APPAHD CONST 10-23-98 - Jan 99

**Re:** Alternative Pedestrian Light Pole  
footings for Arapaho Streetscape  
Project

Re: Arapaho Rd - Pedestrian Light Bases

**STREET LIGHT FOUNDATION  
12" M.H. & 17" M.H. HISTORICAL /  
DECORATIVE POLES**

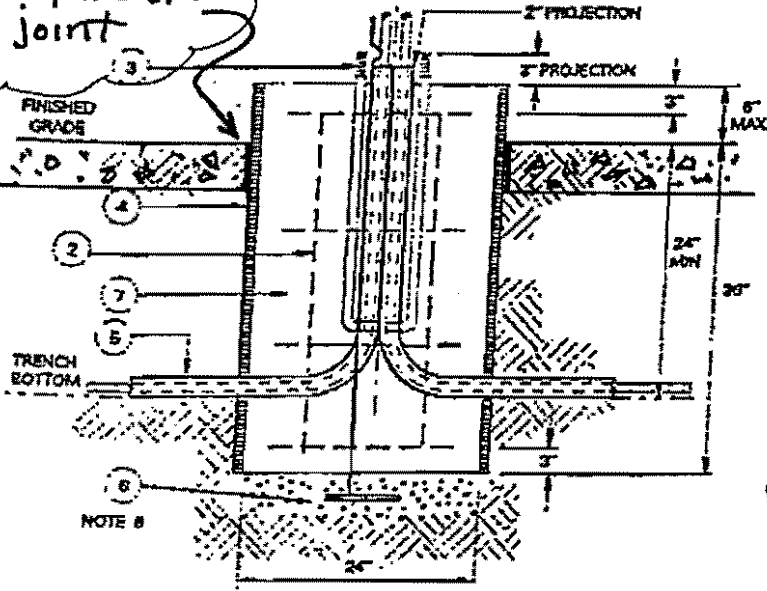
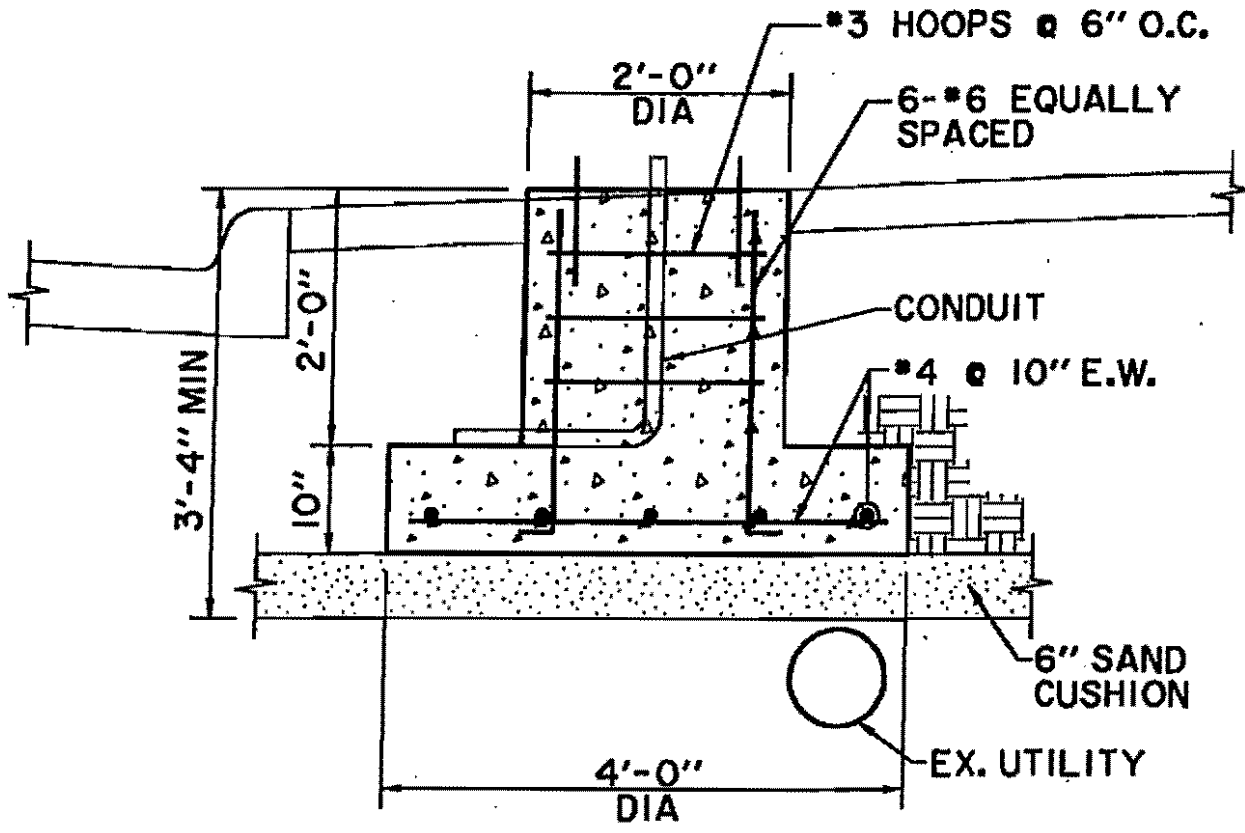
Here are the two light pole footing options for your review. There is a design conflict in the streetscape plans concerning the location and alignment of the Bega pedestrian light footings in relation to the tree well drain line. The plans call for placing the drain and the light pole footing in the same alignment, thus, the 5' deep footing will interfere with the drain line, which is approximately 4' deep.

Please let us know what Mesa's recommendation is regarding Option Number 1. If the contractor was to encounter the drain, then we need a recommendation on using Option Number 2. Our opinion is to use Option 1 if you approve. If the drain is encountered, then the contractor would need to use Option 2.

Please give us a recommendation on the expansion joint as well. We will need Mesa to sign off on these options once reviewed and approved.

THIS WAS NOT IN YOUR ORIGINAL PLAN. I BELIEVE WE NEED IT. YOUR THOUGHTS?

*1-29-99- Ken thinks this would be OK as long as the TU decorative pole & the Bega Pole are similar*

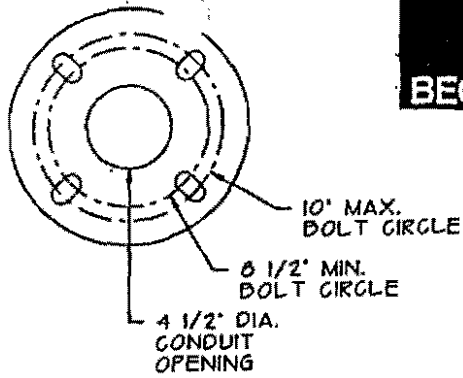
Comments: We originally planned to use a light foundation 22"  $\phi$  by 5' deep. However, the lights are located right on top of the tree drains that are about 4' deep. We thought about moving the lights but have eliminated that idea. Attached is a cut sheet of the light pole and a proposed light base that TU has "approved". Our light base will be placed in disturbed soil from the tree drain installation, but will be held very rigid at the top by the sidewalk. Use of this light base will allow the lights to be placed where we want them. Please give me an opinion about this proposal. Thanks

Arapaho Rd Revised Light Base Location

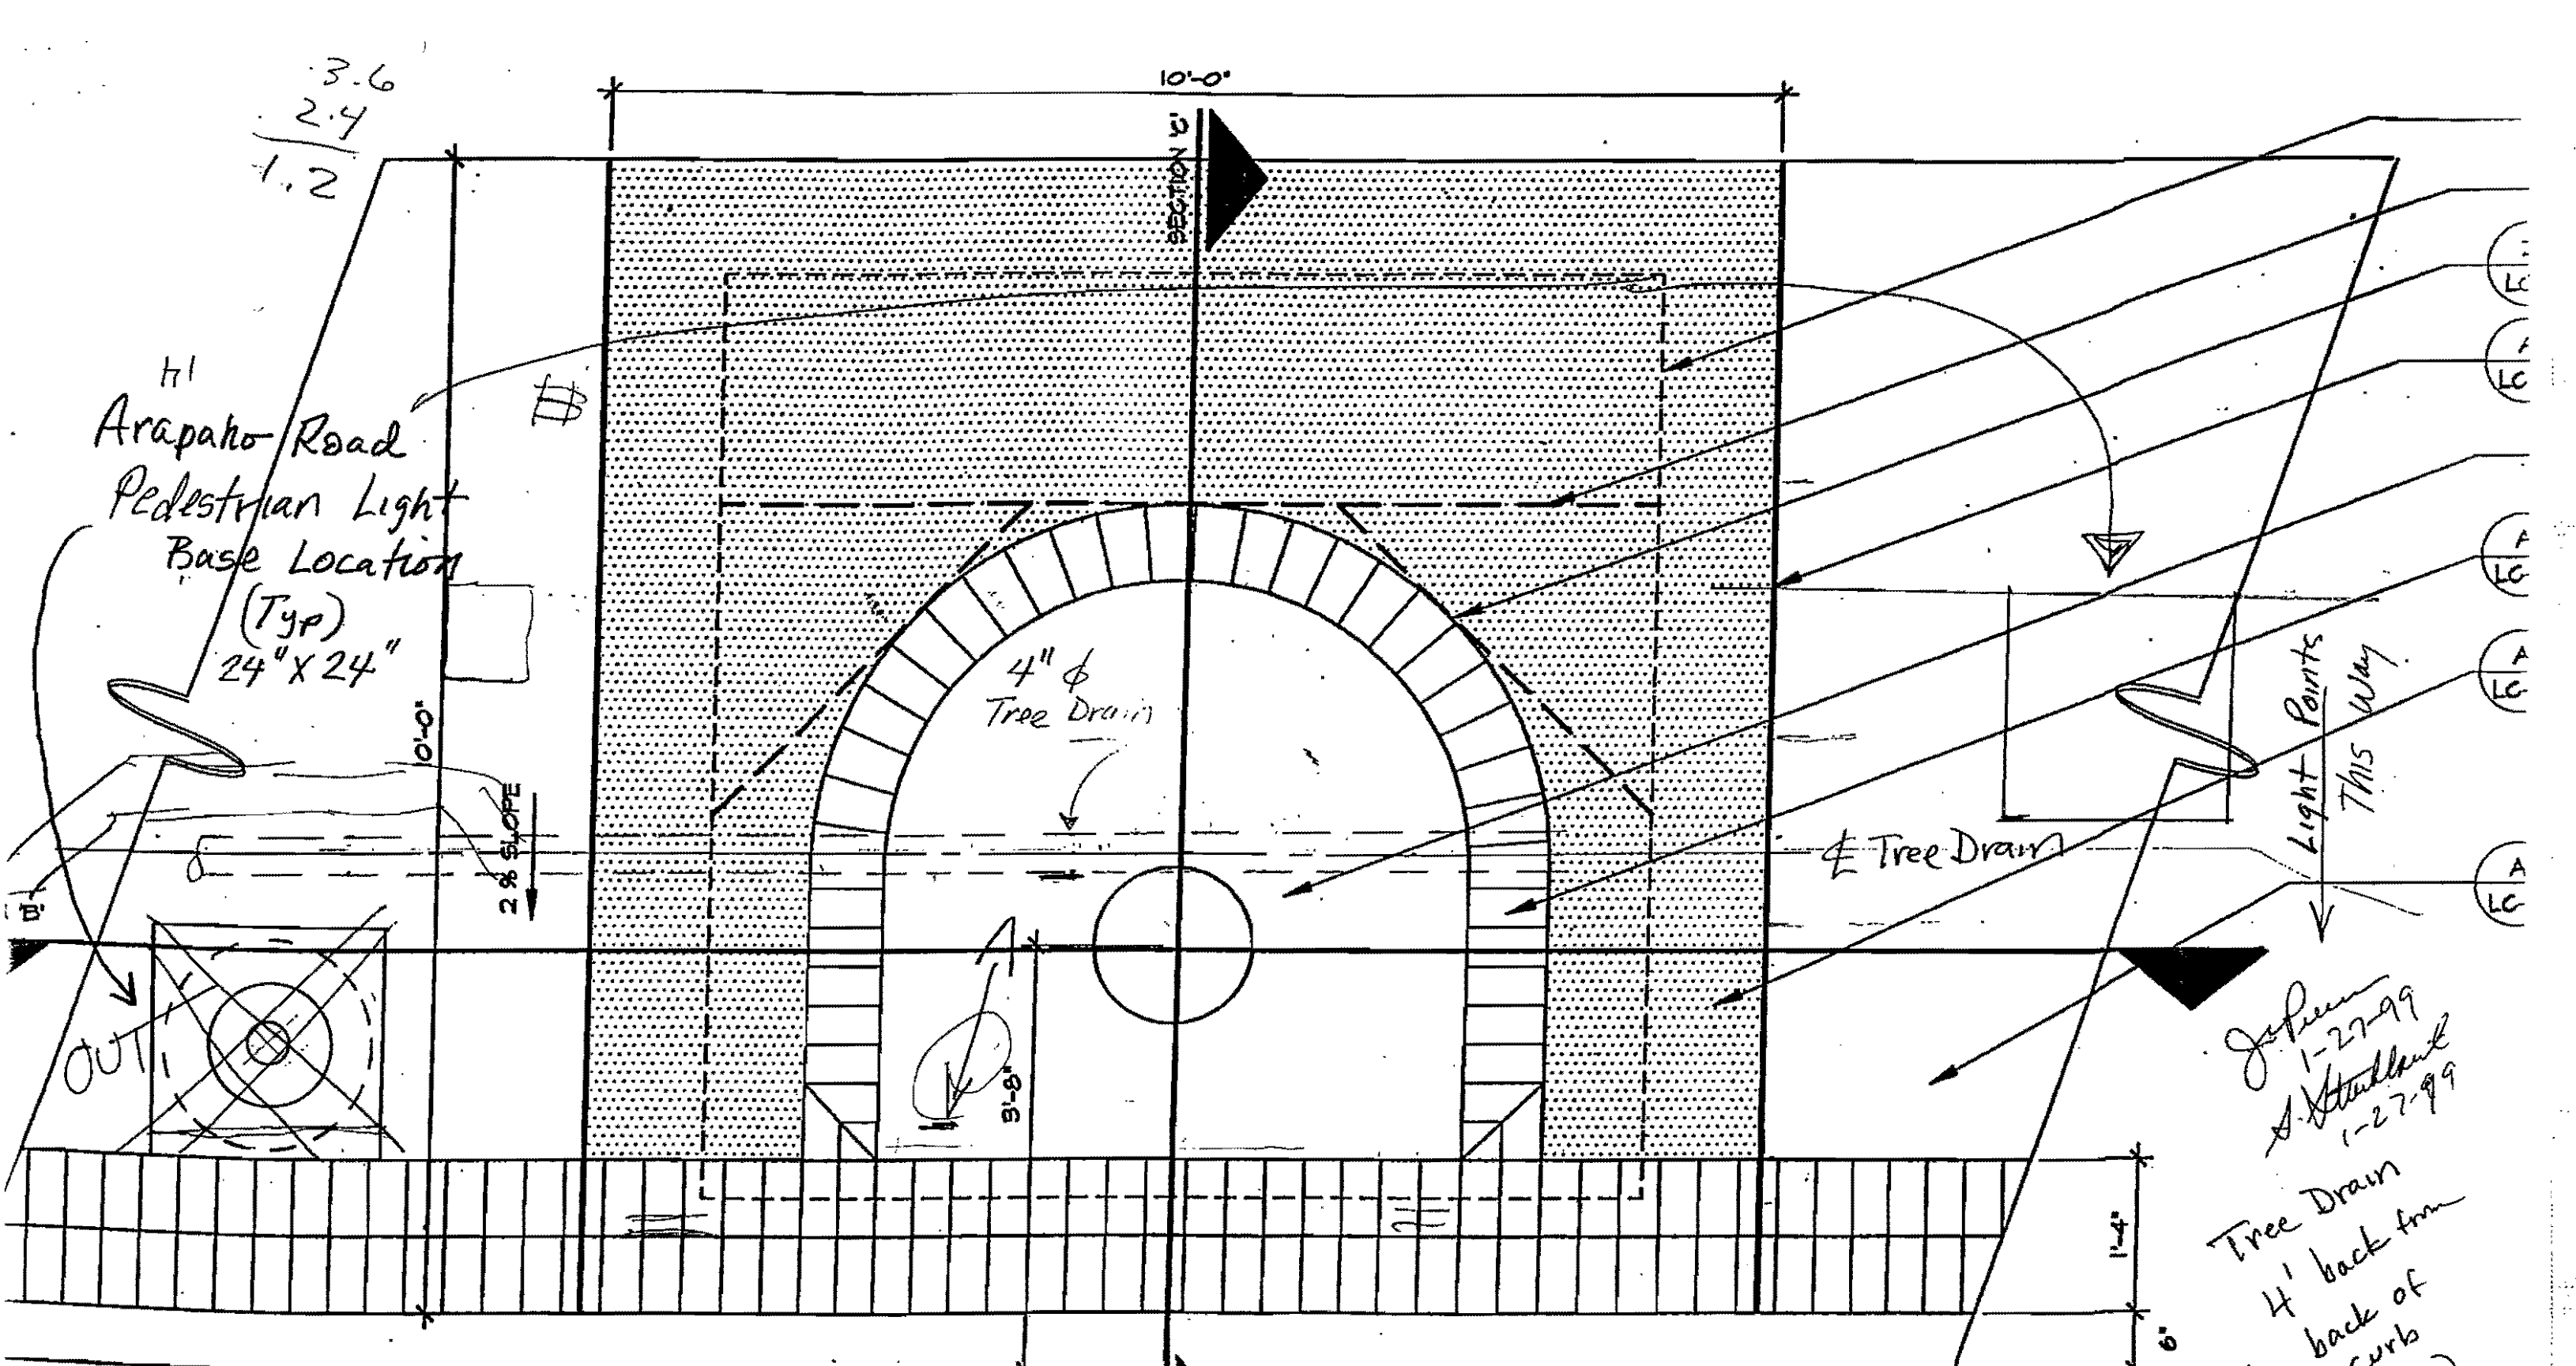
Align off of Tree Well as shown  
Use Round Top?

**VOID**  
Light poles to be placed  
in original location

Note: Center Light Bases between Tree Walls as shown on plans

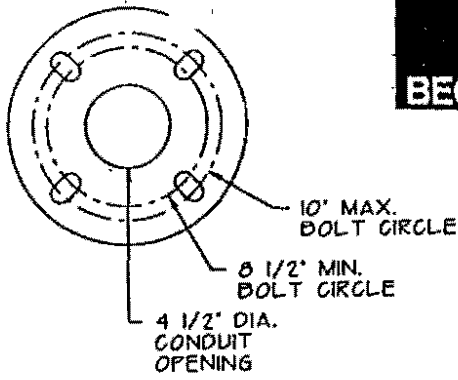
Our electrical subcontractor has proposed a change to the BEGA light pole foundation detail shown on plan sheet LC-4. They have proposed constructing the top portion of the light pole foundation as a 24" by 24" square rather than the 14" circle shown on detail A. The top of the base will have 3/4" chamfer edges and the top of the foundation will be three inches above the top of the proposed sidewalk or brick pavers. Please inform our office of your decision regarding this proposal.

*Circular foundation is 22" dia  
in Detail A, Sheet LC-4. This*

*dimension to remain the same. Top of foundation  
shall be a minimum of 4" above top of sidewalk  
or brick pavers.*

**A** ARAPAHO/QUORUM PLAN  
1"=20'-0"

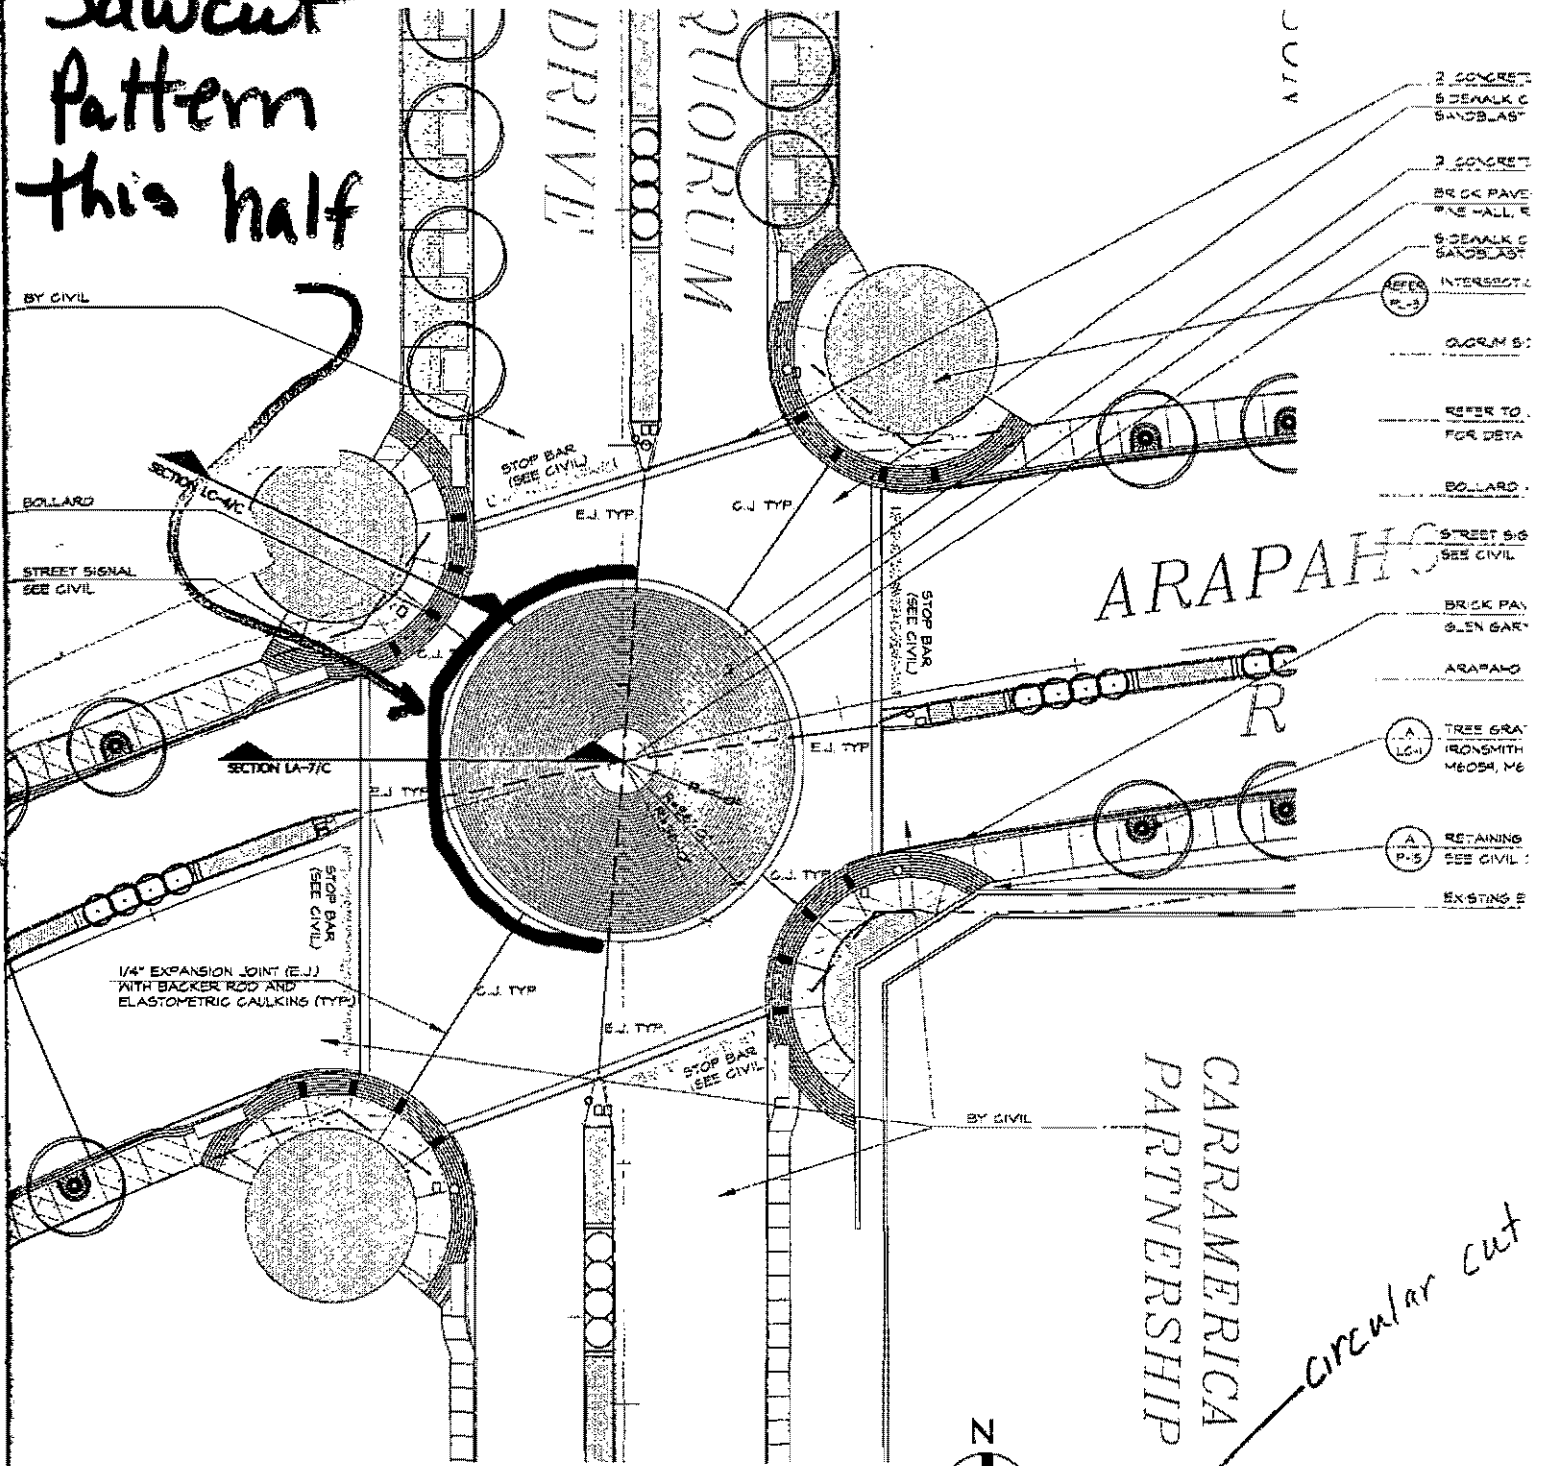
Comments: Ken - we will be pouring  
the west half of the Circle soon.  
What do you think the sawcut  
pattern should be within the circle?  
If any. Note we have expansion joints  
at the "Quarter points" of the circle.

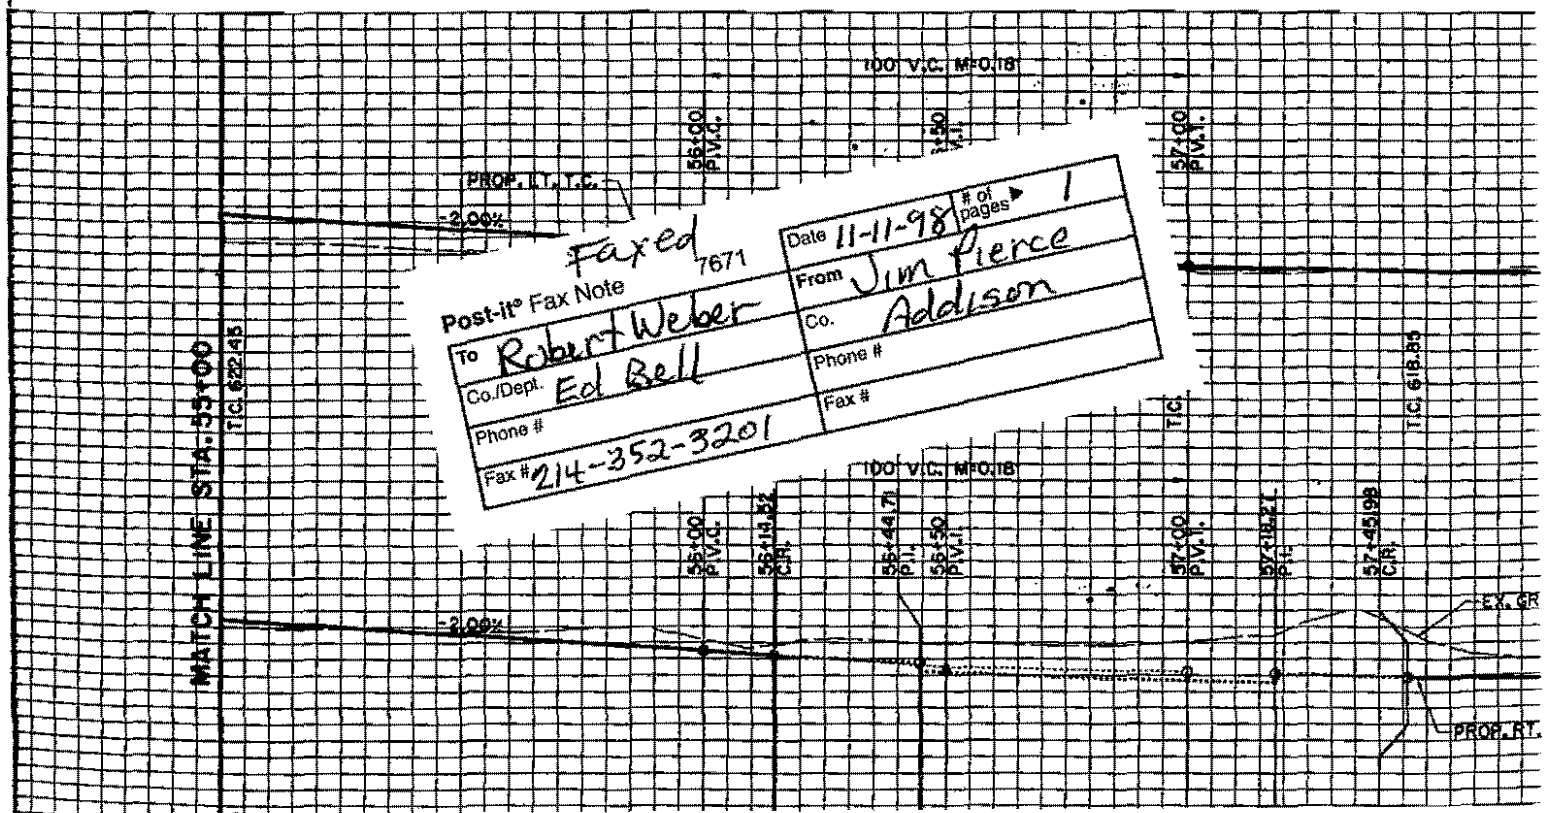
OK to remove tree @ this location that conflicts with sidewalk.

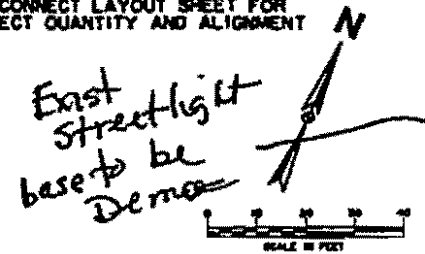
This shows an existing street light that needs to be moved over a couple of feet into the new median. For now, it needs to be taken down so work can proceed. Please enter this into your list of things that need to be done. Need this ASAP.

Y' INLET APRON  
MODIFICATIONS  
ARAPAHO ROAD  
PLAN SHEET ST-15  
NOVEMBER 2, 1998

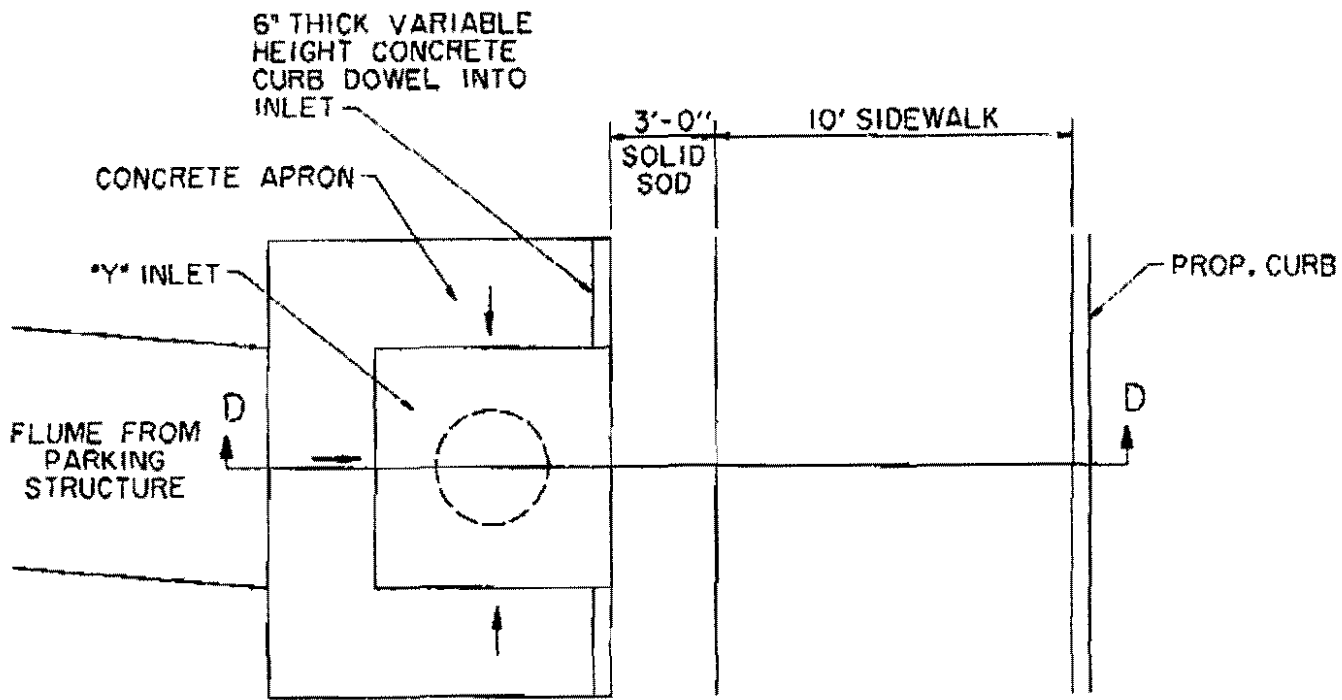
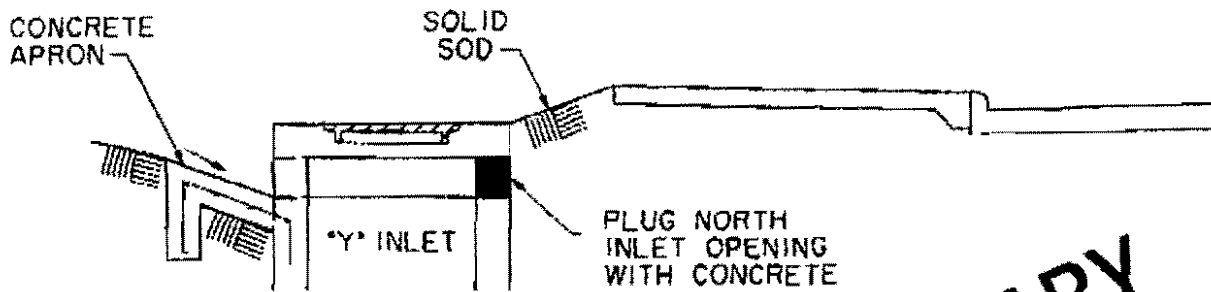
Comments: The flow to this inlet is  
9.99 cfs (from drainage map). The drawing  
shows what we want to do - block  
off some of the opening(s) and fill  
in between the inlet & sidewalk.

The calculations are my rough estimate  
of the capacity of the Y inlet with just  
one full side open. 2 other sides would  
add a little more capacity. Based on  
my calcs, the water would not exceed  
the elevation of the top of the inlet &  
probably would be less.

11-6-98  
alternatives to this  
were discussed. See  
meeting notes of this  
date
